# Service Bulletin N° 74

# SEGA™ PINBALL, INC.

**RE:** Modification to **BAYWATCH™** Early Production Games

Fig. 1

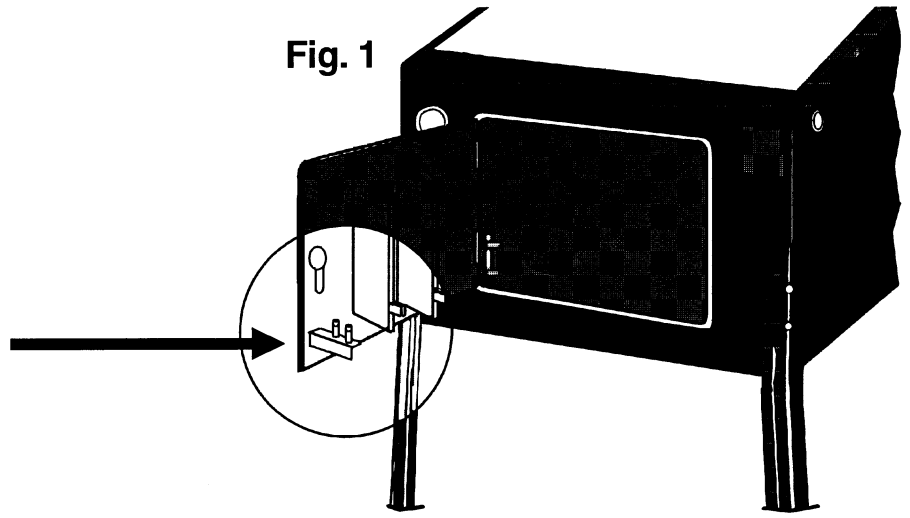
Open the Coin Door and locate the Service Switch Set Bracket & Coin Door Mounting Bracket. (See Fig. 1)

Fig. 2

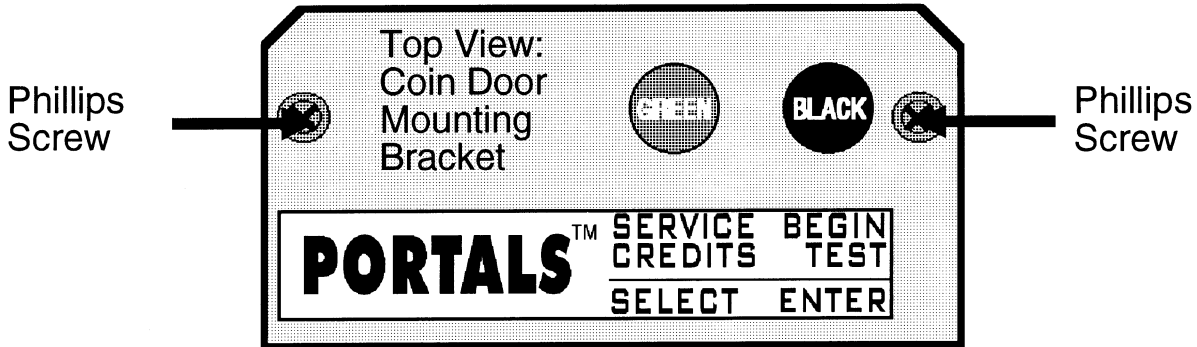
Remove the 2 Phillips Screws securing the Switch Set Bracket to the Coin Door Bracket. (See Fig. 2)

Fig. 3

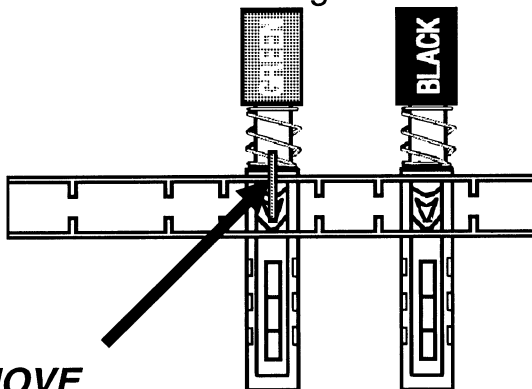
The Switch Bracket will now be separated from the Coin Door Bracket still attached by the wires. (See Fig. 3)

Locate the Green Button Switch. Remove the silver "C" shape wire form from the switch. The switch is now a "non-interlocking" Momentary Switch. (See Fig. 3 & 4)

**REMOVE**  
Silver "C" Shape  
Wire Form
